EPC STORMWATER REVIEW COMMENTS
IN ORANGE BOXES WITH BLACK TEXT

Landscape Endeavors Building Addition

Commercial Construction Drawings

Landscape Endeavors Building Addition
CES Endeavors, LLC
Civil Site Plan
El Paso County, Colorado

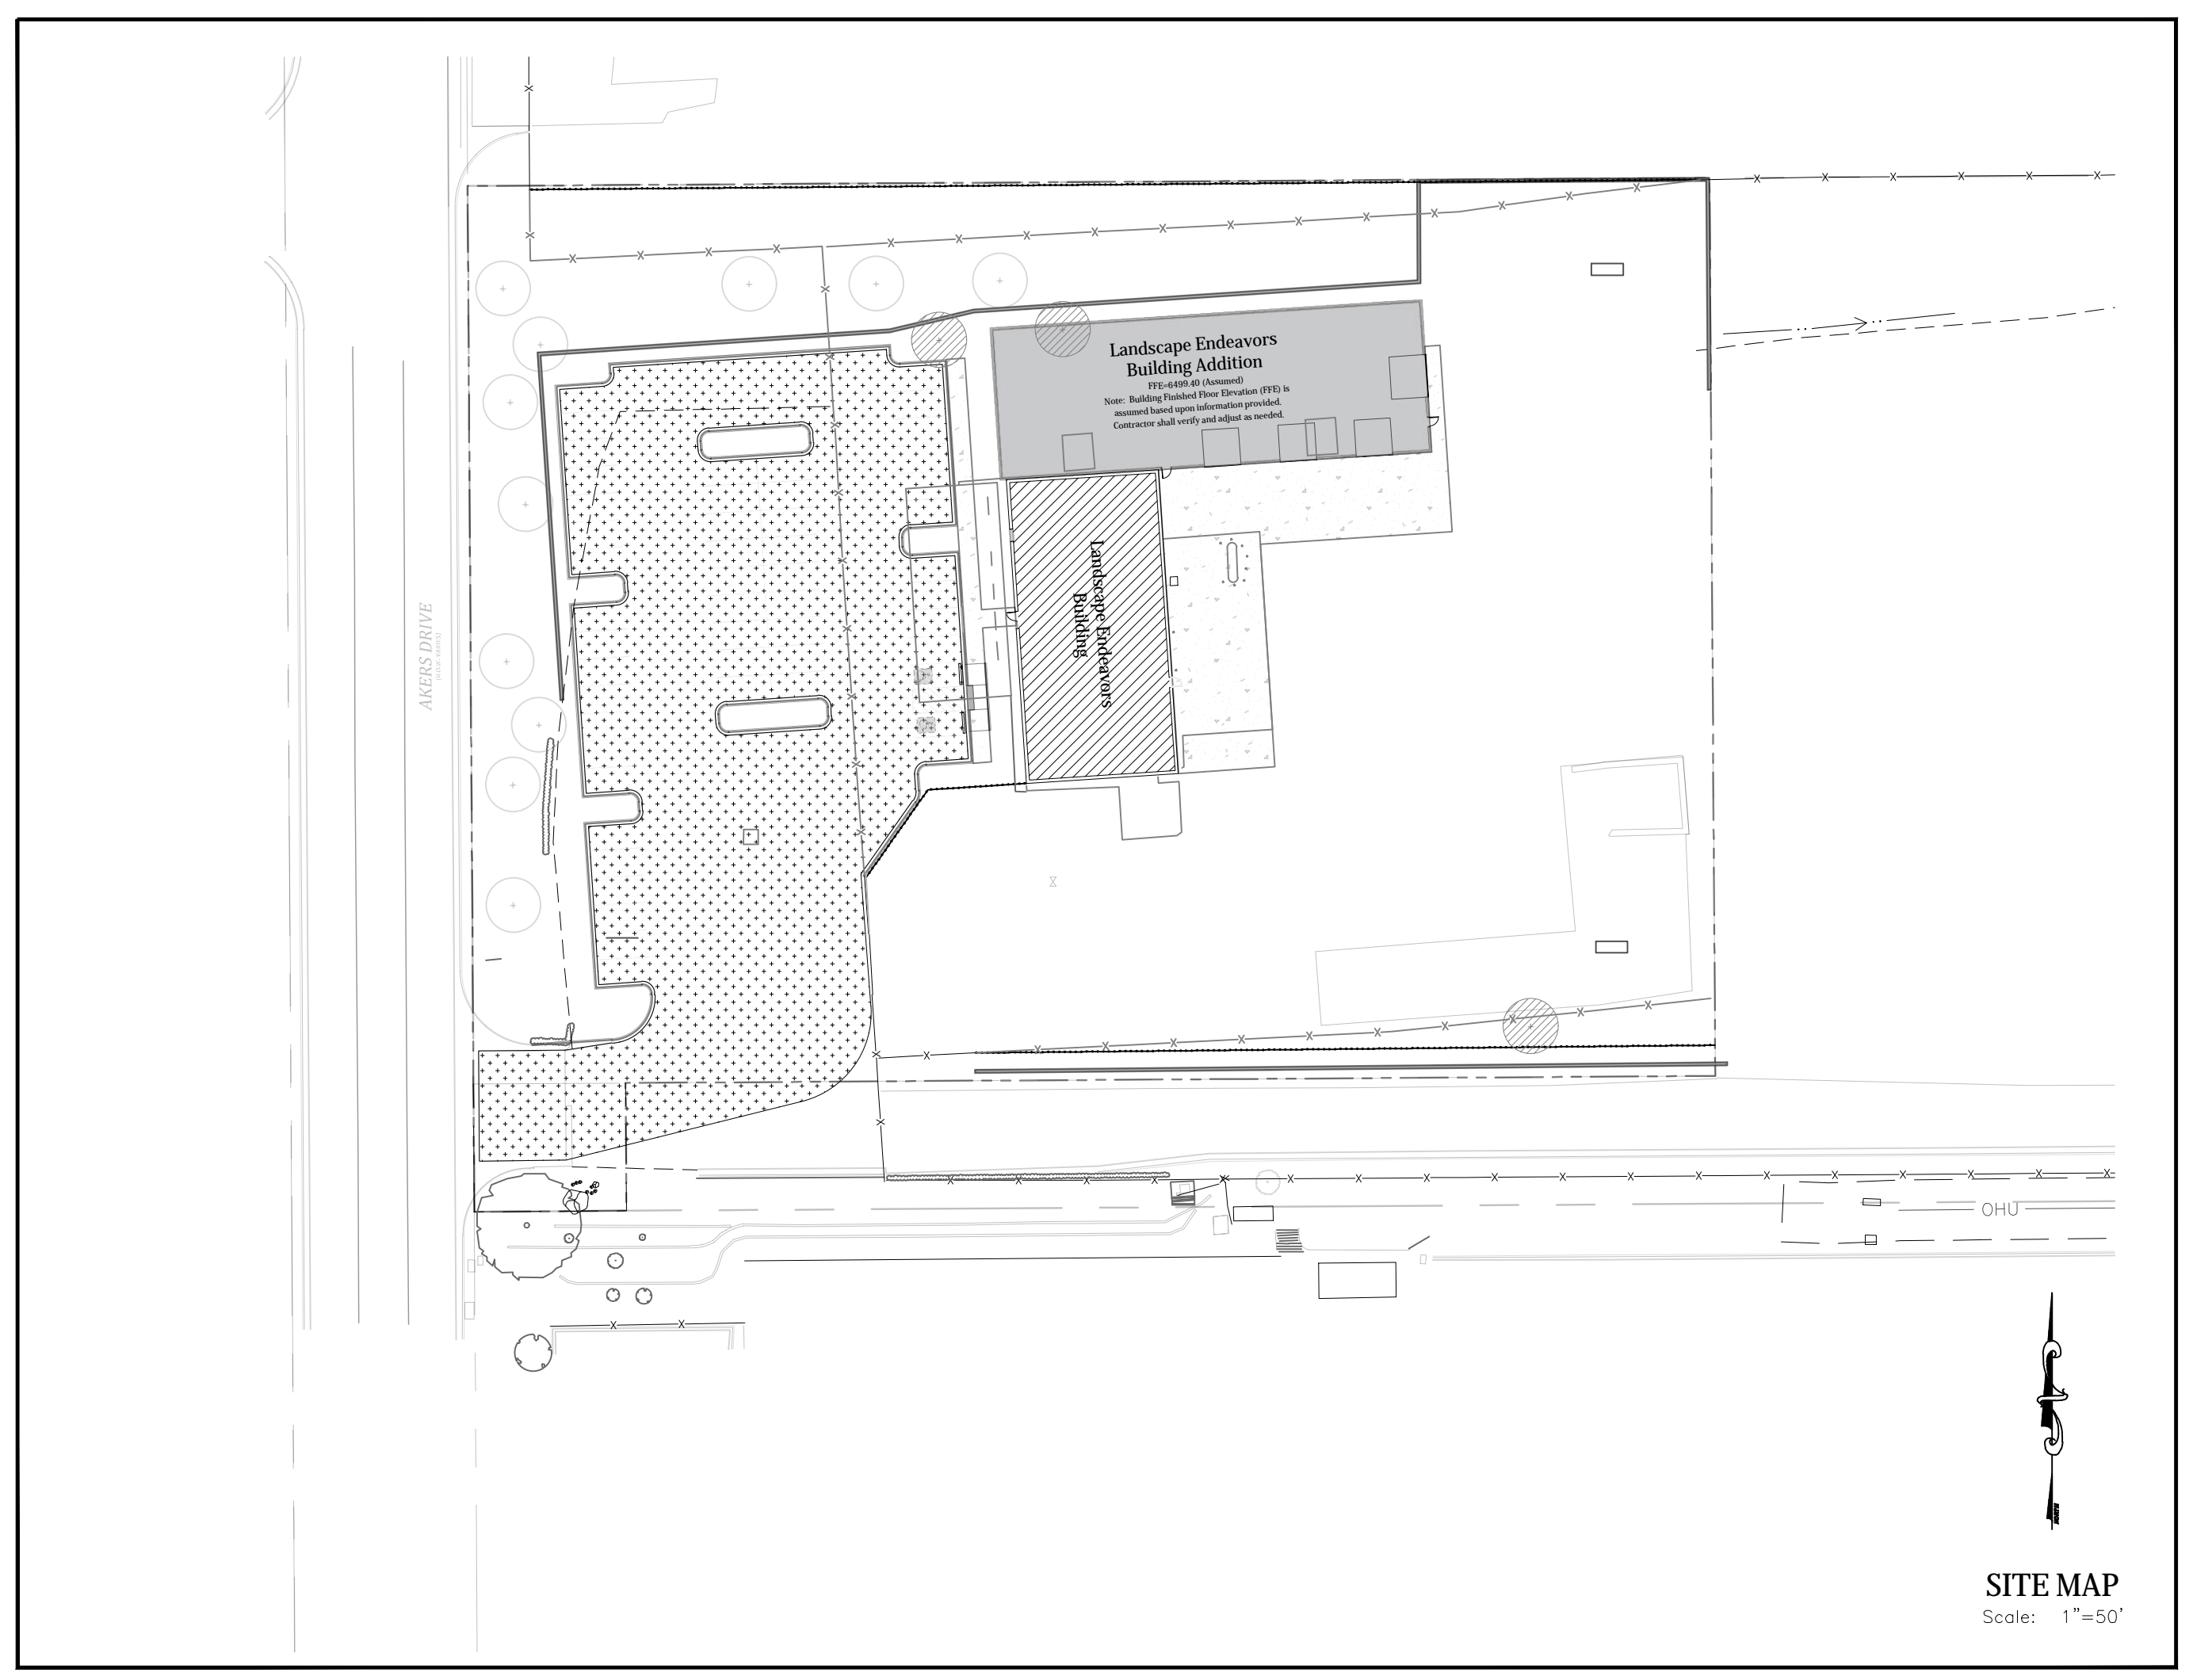
Note there is no public improvements such that construction drawings dont apply. The county will only be endorsing the GEC plan sheet set

Grading and Erosion Control - Cover Sheet

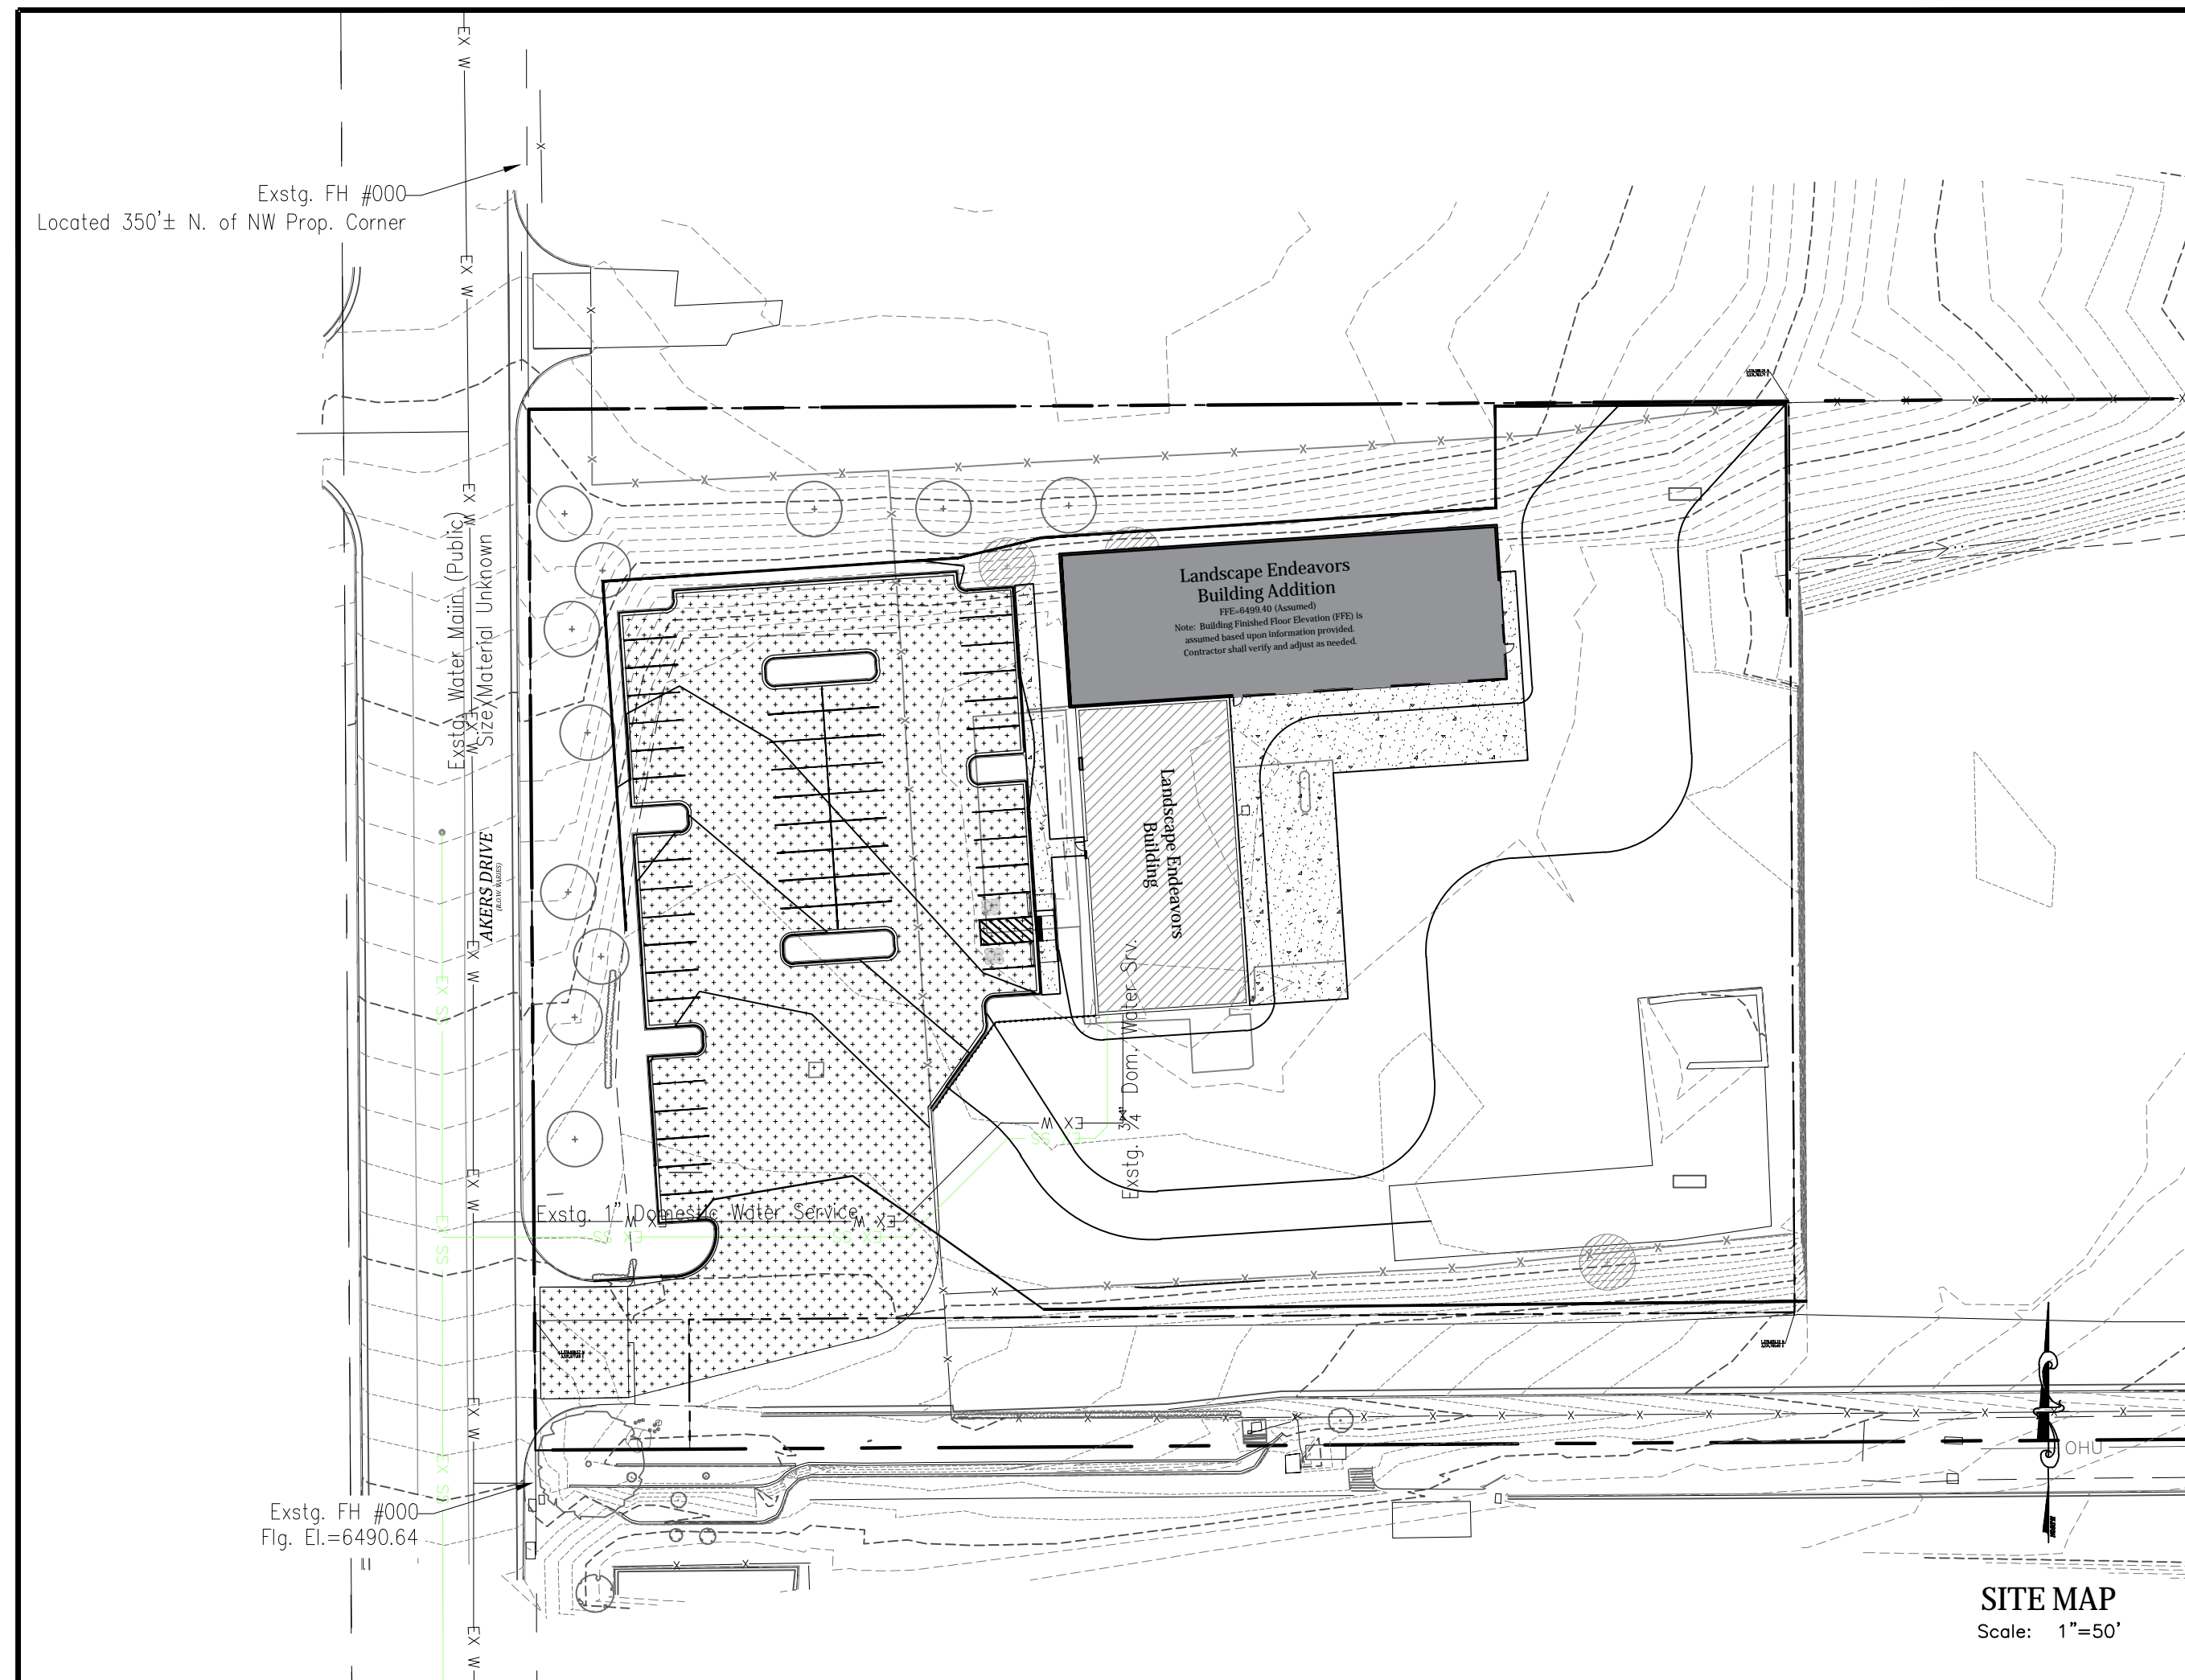
Please correct signature blocks

Project No.: 24060
Date: January 31, 2025
Design: AWMC
Drawn: CAD/TG
Check: TAC
Revisions:
Sheet
C300
of 13 Sheets

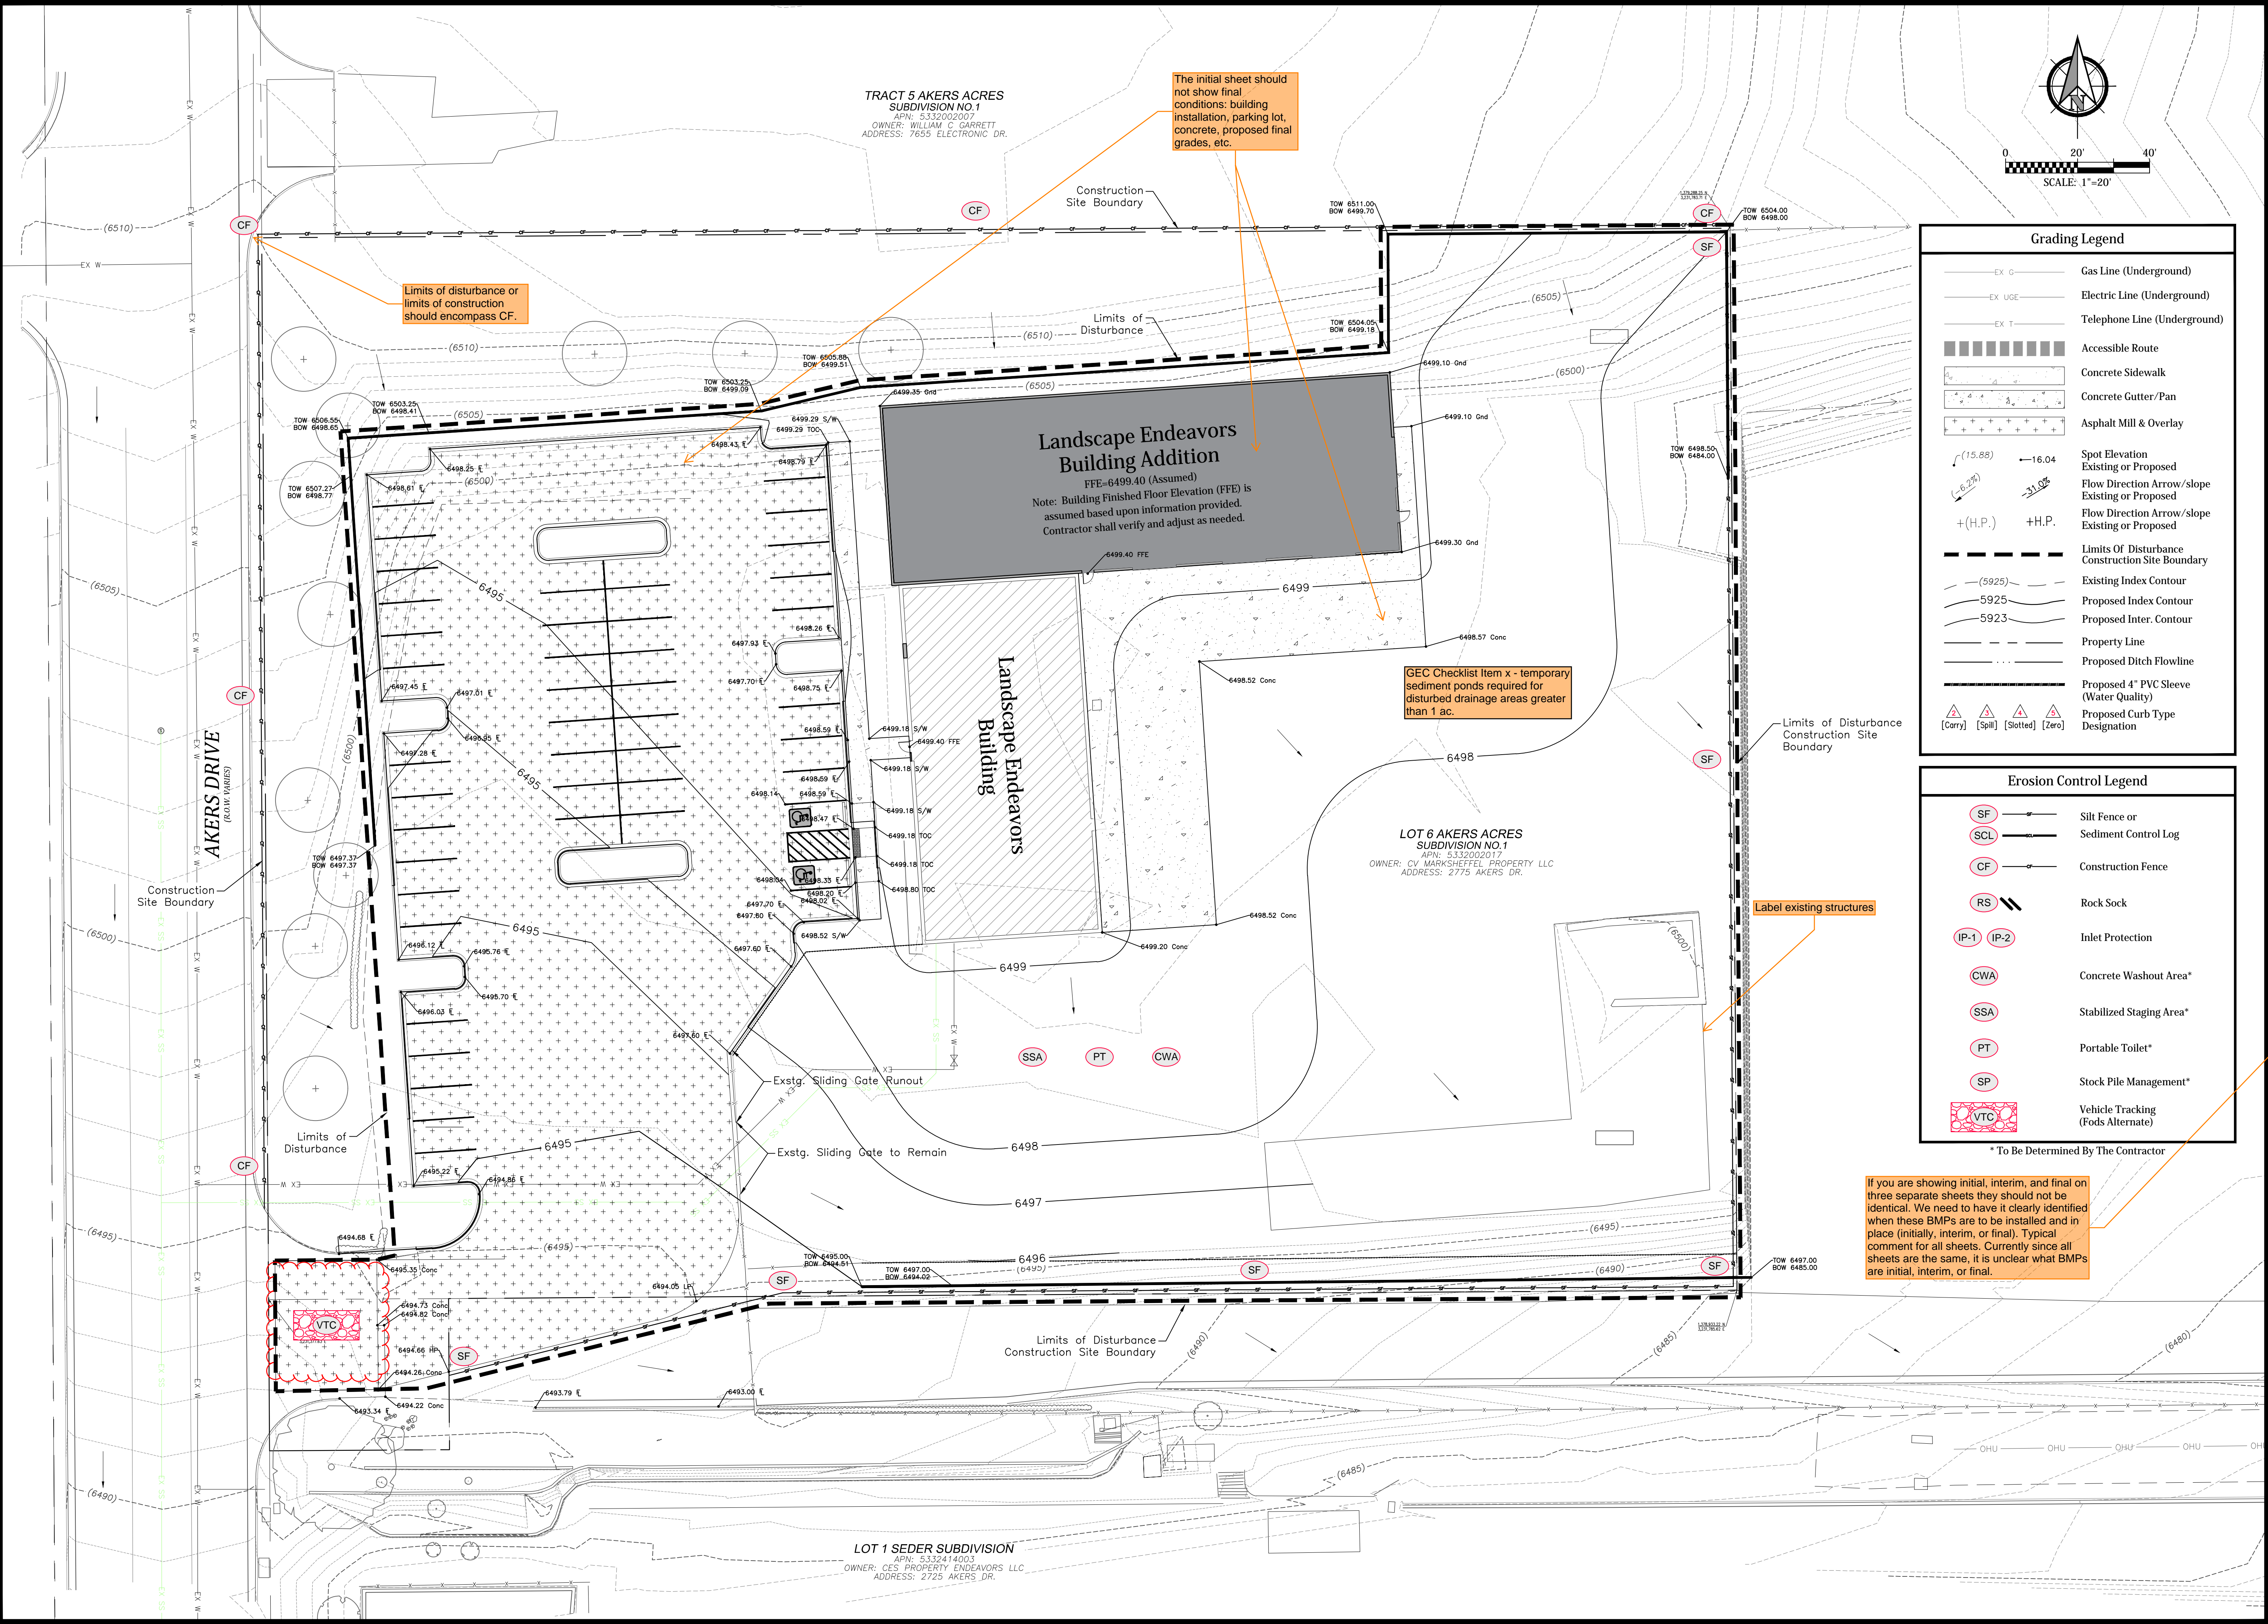
The initial sheet should not show final conditions: building installation, parking lot, concrete, proposed final grades, etc.

If you are showing initial, interim, and final on three separate sheets they should not be identical. We need to have it clearly identified when these BMPs are to be installed and in place (initially, interim, or final). Typical comment for all sheets. Currently since all sheets are the same, it is unclear what BMPs are initial, interim, or final.

SWMP Checklist Item 17d - Show areas of cut/fill
